**SOLOMON PROJECT
RESPONSE TO PUBLIC
SUBMISSIONS
EPA ASSESSMENT NO. 1841**

**8 March 2011
SO-RP-EN-0007**

Document Title:	Solomon Project: Response to Public Submissions EPA Assessment No. 1841
Document No:	SO-RP-EN-0007
Document Type:	Report
First Issue Date:	11 January 2011

Figure 5.

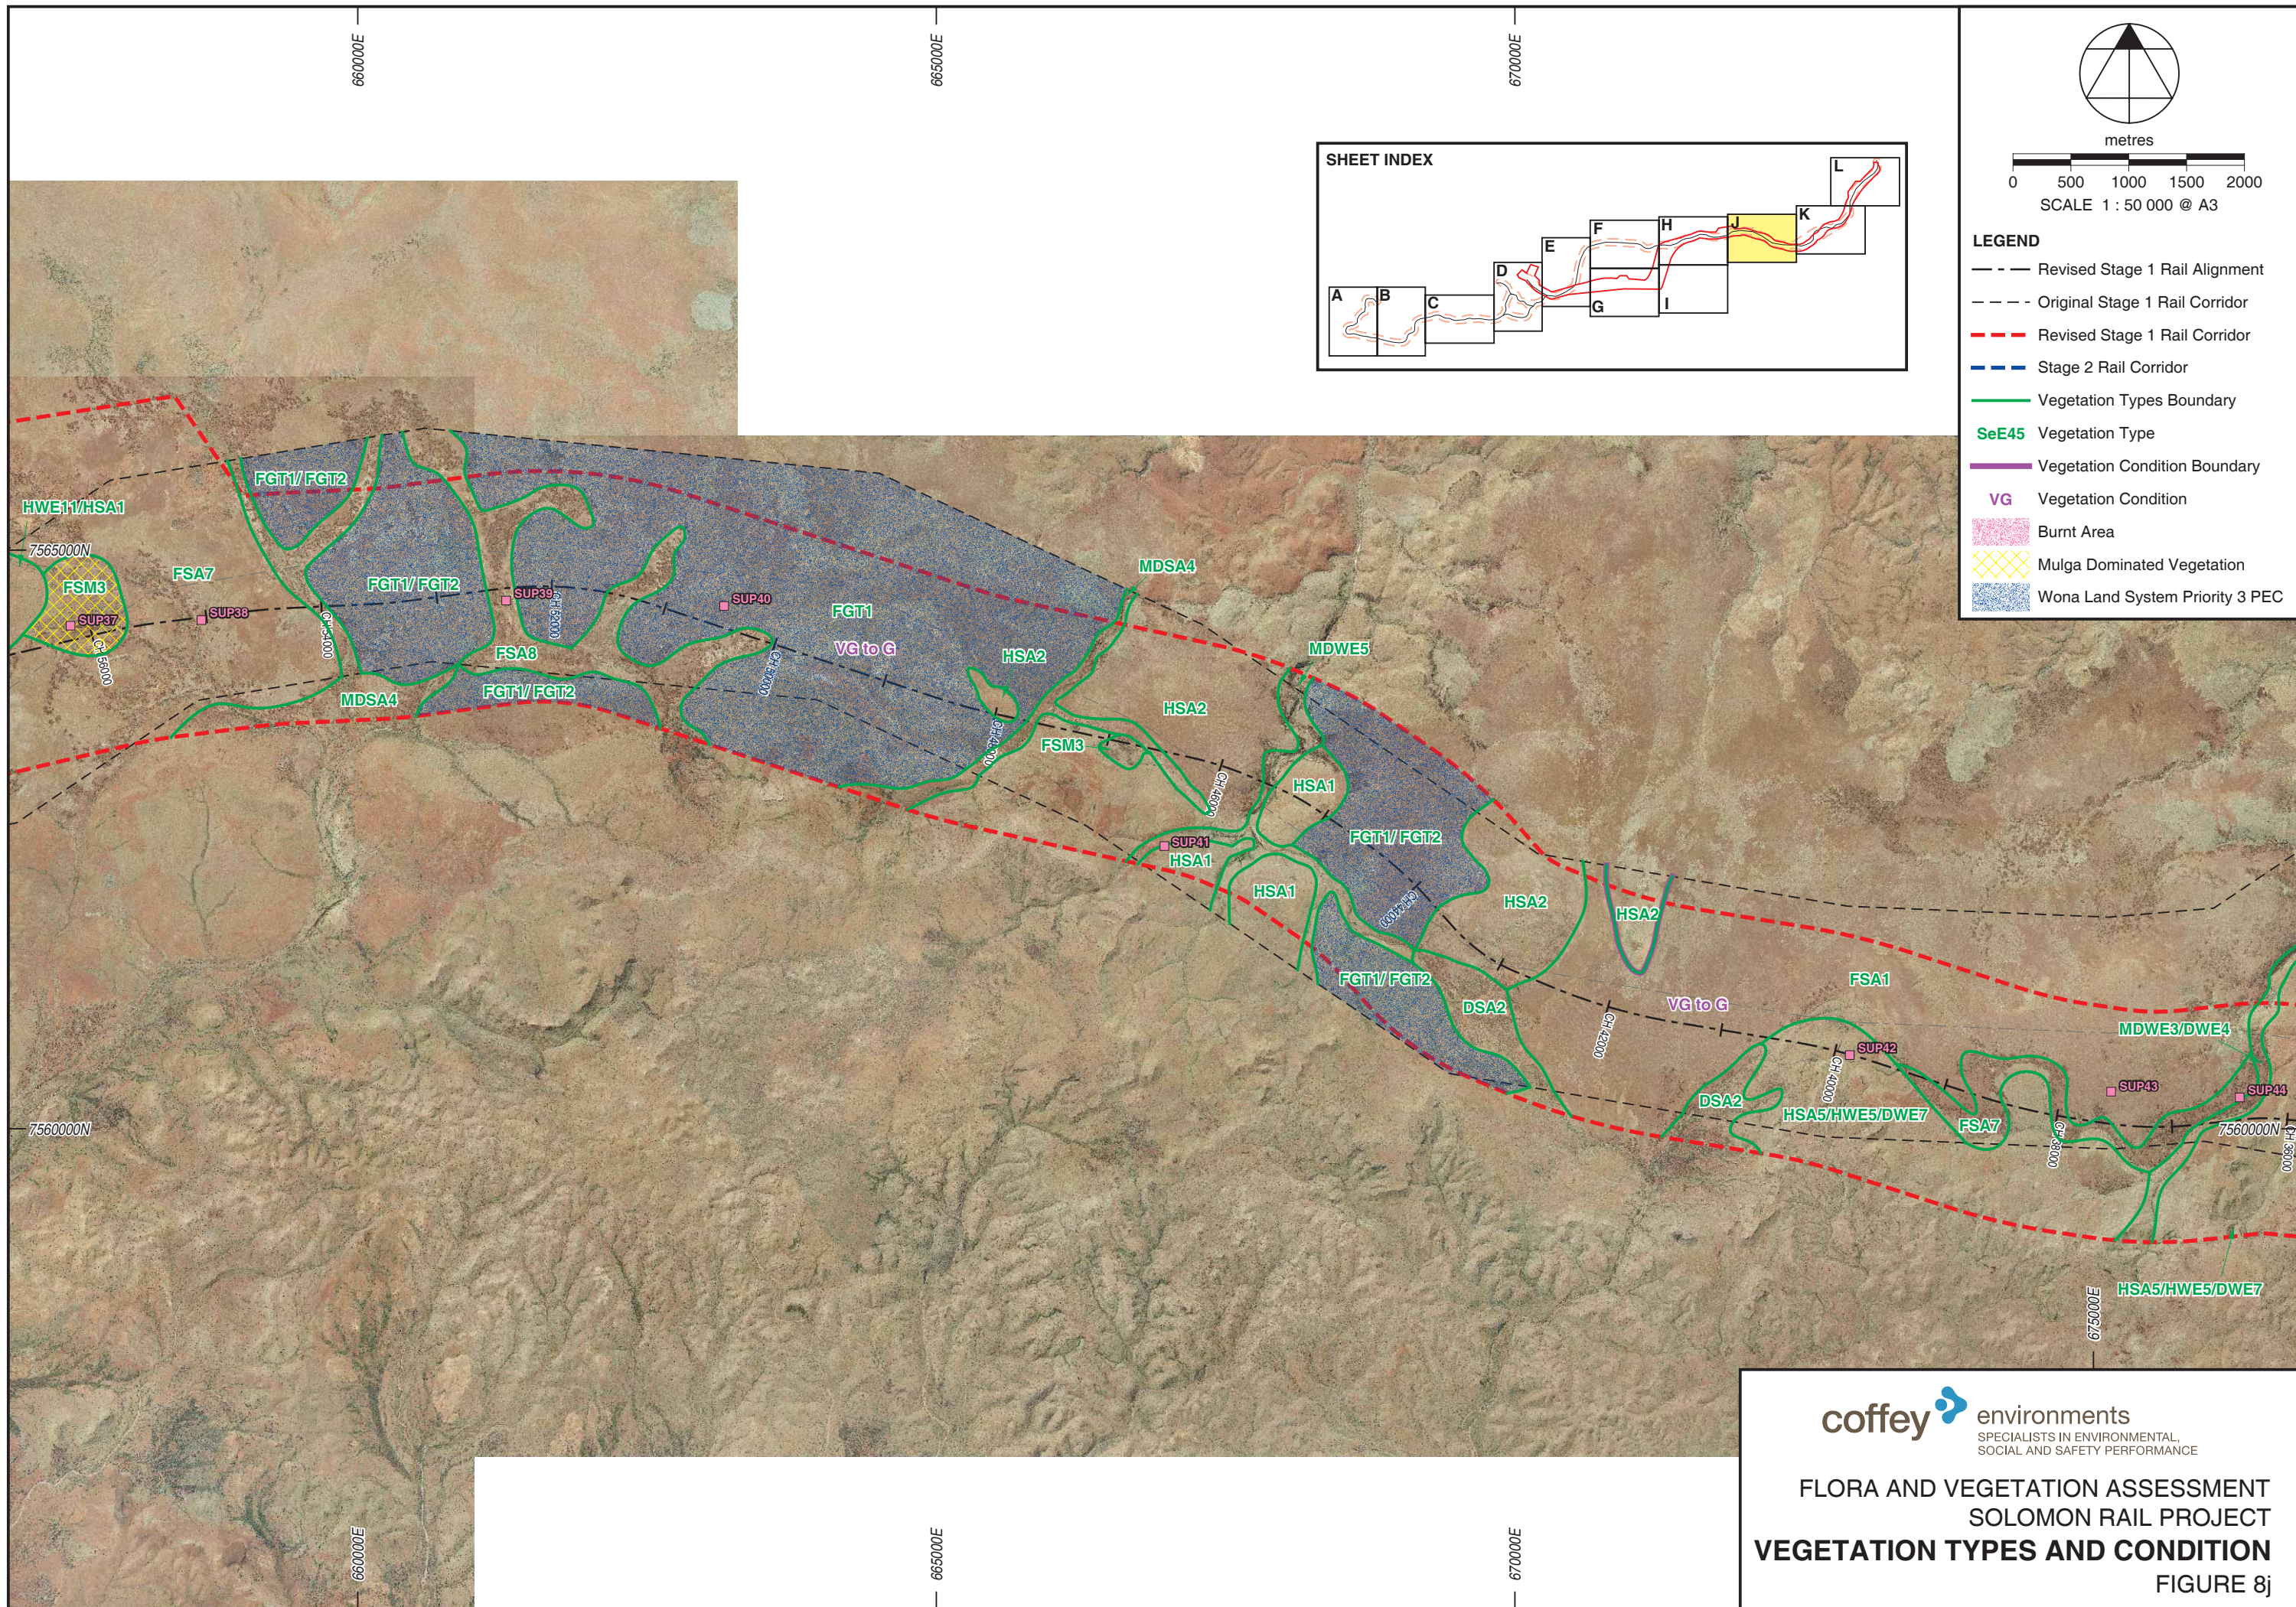
Recommendation 15: *That the proponent identifies impacts of the Solomon Project on the 'four plant assemblages of the Wona Land System' priority ecological community (PEC) using maps and explaining the specific impacts on the different floristic units within the PEC.*

*Discussion: The 'four plant assemblages of the Wona Land System' PEC has been identified by the proponent as occurring in the survey area. The PER states that 185 hectares of this PEC are proposed for clearing (p. 164), although the actual location of this area is not easily identifiable from the PER. This PEC consists of a series of four units with different priority ranks, but no information has been provided about which of these are proposed for clearing. Additionally, no information has been provided in the PER about the regional distribution of the Wona Land System units proposed for impact, nor about how the proponent will seek to avoid, manage or minimise impacts on this priority vegetation. The Wona Land System units have different priority rankings and are described as follows: Annual sorghum grasslands on self-mulching clays (Priority 1) - this community appears very rare and restricted to the Pannawonica-Robe valley end of Chichester Range; Grassless plains of stony gibber covered by a very rich herbfield (mostly peas and Convolvulaceae) after rain (Priority 1); Mitchell grass plains (*Astrebela* spp.) on gilgai (Priority 3); and Mitchell grass and Roebourne Plain Grass (*Eragrostis xerophila*) plain on gilgai (Priority 3).*

The Wona Land System, formerly referred to as the "Plant Assemblages of the Wona Land System" was recently (3/05/10) divided into 4 sub-units, two of which are classified as Priority 1 PECs and 2 as Priority 3 PECs. Based on vegetation mapping and floristic data collected from the flora and vegetation survey of the Solomon rail corridor, the Solomon Rail corridor contains two of the 'Four Plant Assemblages of the Wona Land System' PEC. The two sub-units are:

sub-units occurring within the study area are Priority 3 PECs. The attached mapping shows the precise location of the 'Four Plant Assemblages of the Wona Land System' PEC containing these 2 sub-units. Both sub-units have been mapped based on the vegetation mapping, specifically vegetation type FGT1 (Tussock Grassland to Open Tussock Grassland of *Eriachne obtusa*, *Eriachne benthamii*, *Eriachne mucronata* (typical form), *Eragrostis xerophila*, *Astrebla pectinata* and *Aristida latifolia* to 0.5m), which they directly relate to. The total mapped area of vegetation containing FGT1 (Wona Priority 3 PEC) within the entire rail corridor is 2146.5ha (see Figure 5). The total mapped area of FGT1 (Wona Priority 3 PEC) proposed to be impacted as a result of the rail construction is 60.41ha. The 185ha area calculated in the PER was based on the Wona Land System as defined by the Department of Agriculture and Food Land System mapping dataset only. The updated area is more specific as it was calculated based on the sub-unit descriptions in conjunction with the vegetation mapping undertaken by Coffey Environments. Therefore, based on vegetation mapping and the descriptions provided by DEC, it is considered that the balance of the area previously provided is not associated with the Wona Land System PEC.

Figure 7.

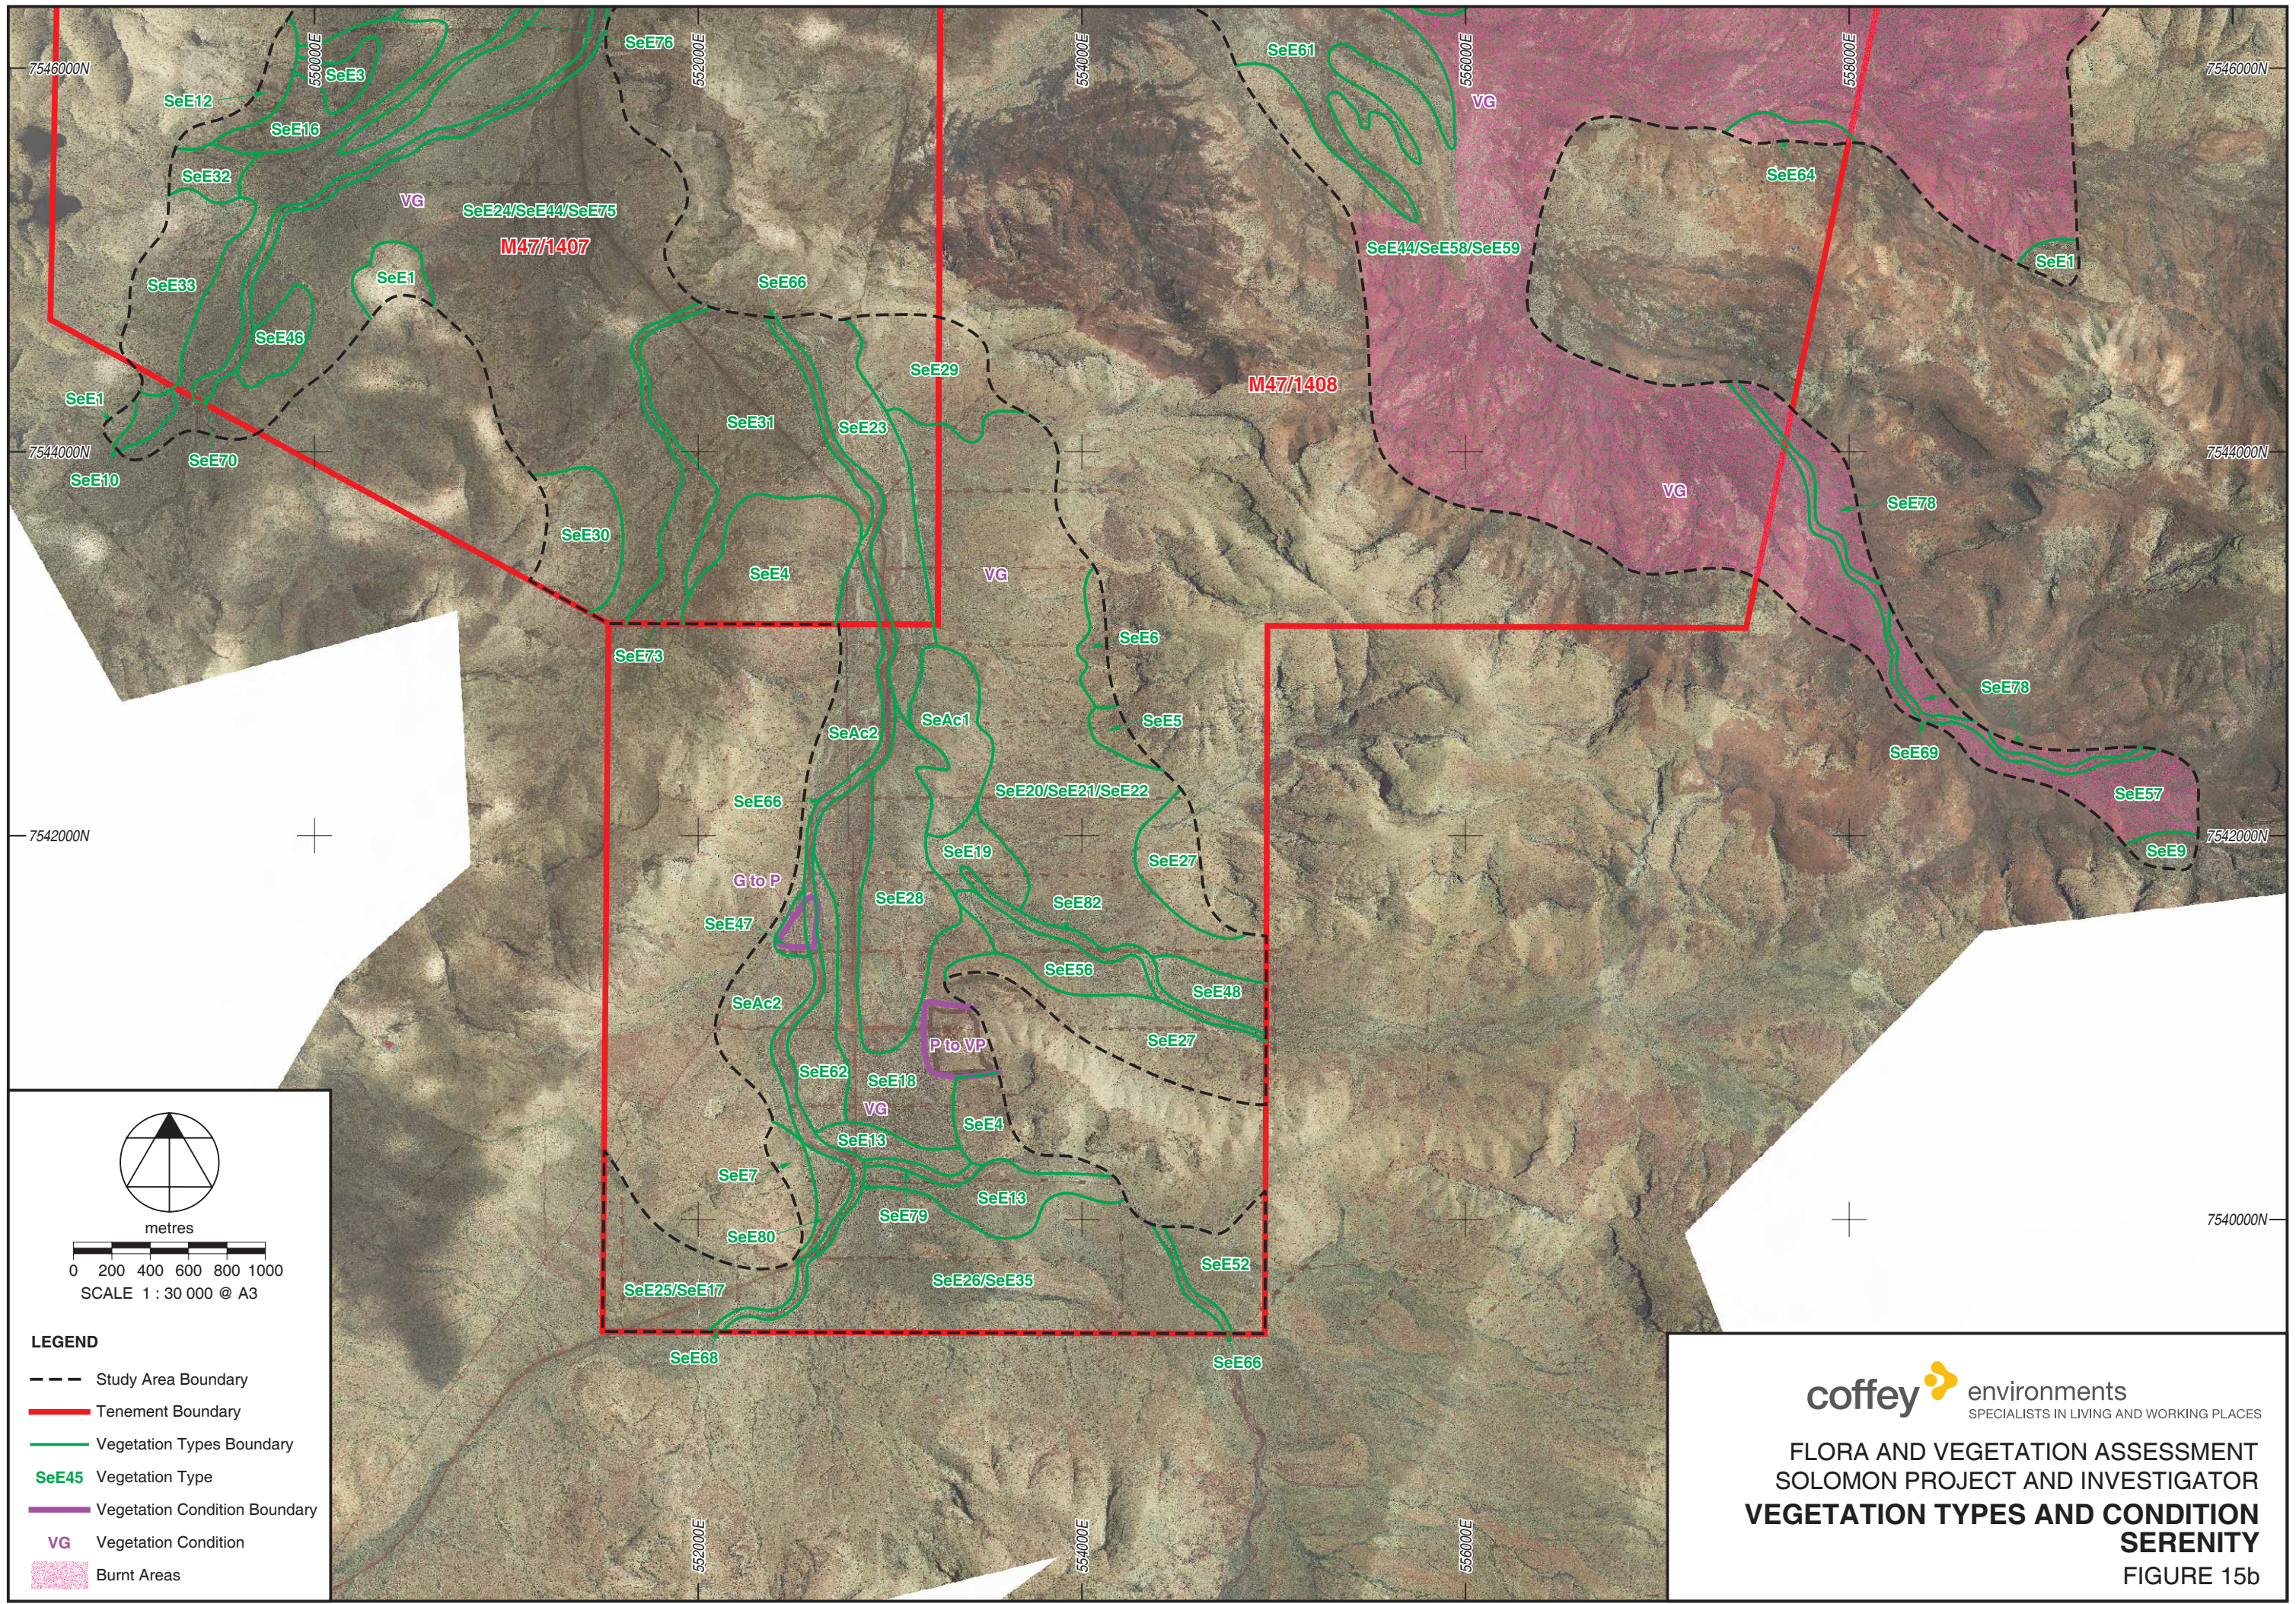
DOW has not reviewed any information on the hydrological or environmental impacts of this remote borefield, and considered current work completed is conceptual. The borefield is not part of the Solomon PER footprint or impact assessment and will require a detailed impact assessment prior to commissioning. The DOW also seeks clarification on timeframes that an additional water source will be required. There is discrepancy between the Water Management Plan (year 8) and the Public Environmental Review document (year 13).

The depth to groundwater associated with the proposed Serenity Valley borefield is greater than 30m (see depth to groundwater plan below). Only a small area of the vegetation type Se81, which occurs in the northern portion of the Serenity Valley area over groundwater at a depth of 35-40m, supports the weakly vadophytic species *Eucalyptus victrix* (see Figure 7). Therefore the potential impacts of groundwater abstraction on the susceptible ecosystems within the proposed borefield at Serenity are anticipated to be minimal.
